The Secretary
NSW Department of Planning, Industry and Environment

13 August 2020

I refer to the Department's below email of 7 August 2020 regarding SSD-5066-Mod-2 request to modify the Moorebank Intermodal Precinct West – Concept Plan and Stage 1 development consent (SSD-5066) located at Moorebank Avenue, Moorebank (Lot 1 DP 1197707) seeking to adjust the southern operational boundary of the MPW Stage 2 warehouse area and amend the maximum building height established across warehouse areas 5 and 6 from approximately 21 m up to and including 45 m. Submissions need to be made to the Department by 24 August 2020.

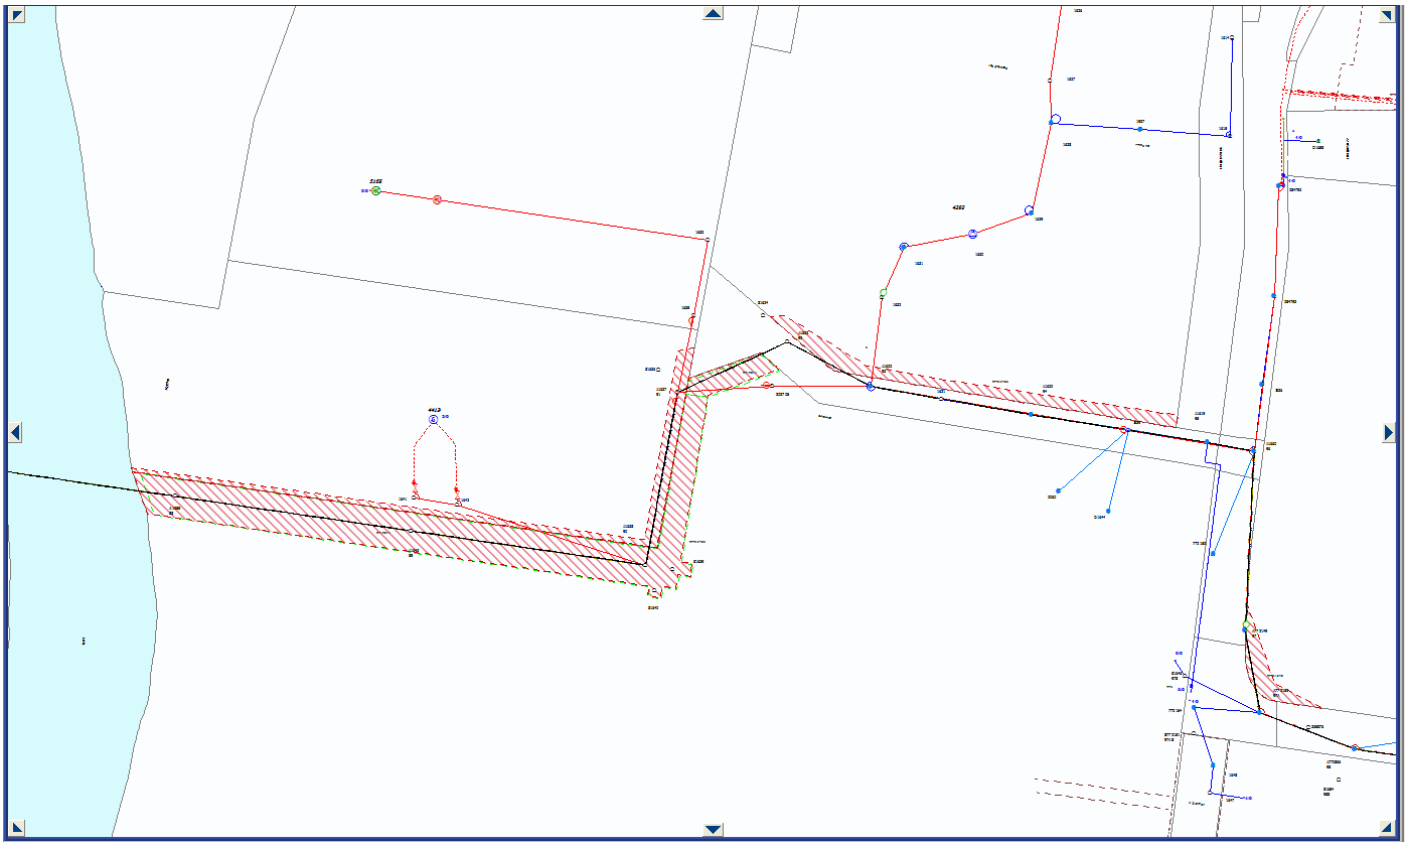
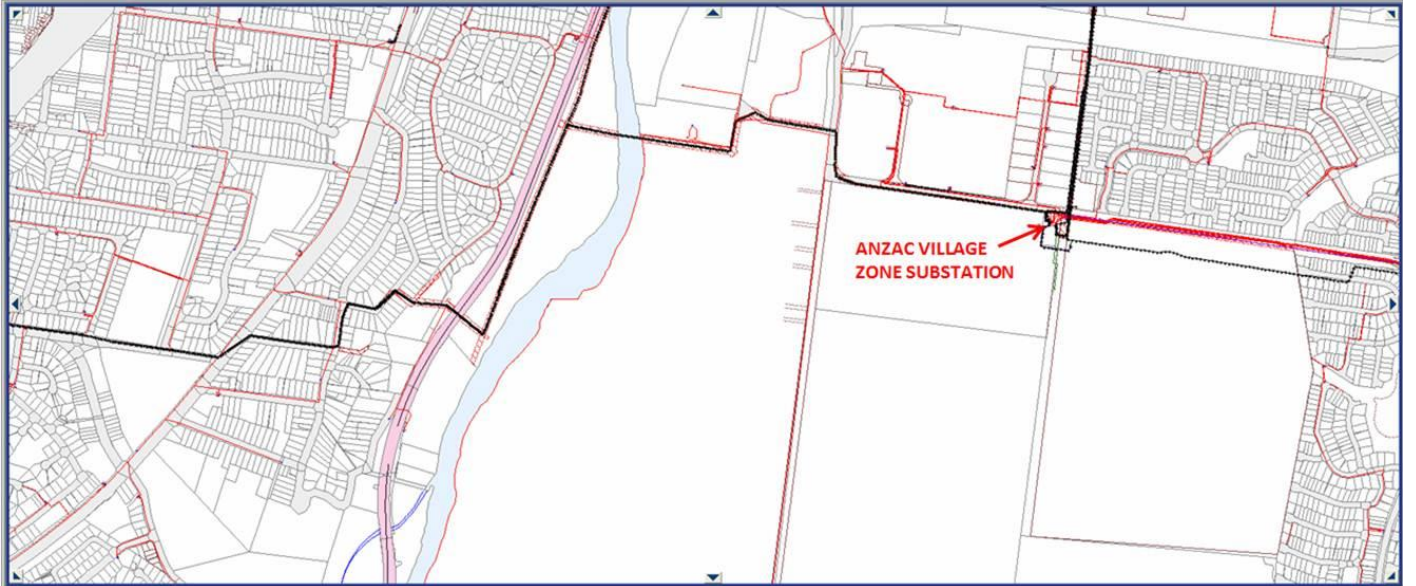
As shown in the below site plans from Endeavour Energy's G/Net master facility model there is significant low and high voltage electricity infrastructure over (including an easement for overhead power lines) and in the vicinity of the site. Please note the location of any electricity infrastructure, boundaries etc. shown on the plan is indicative only and this plan is not a 'Dial Before You Dig' plan under the provisions of Part 5E 'Protection of underground electricity power lines' of the Electricity Supply Act 1995 (NSW).
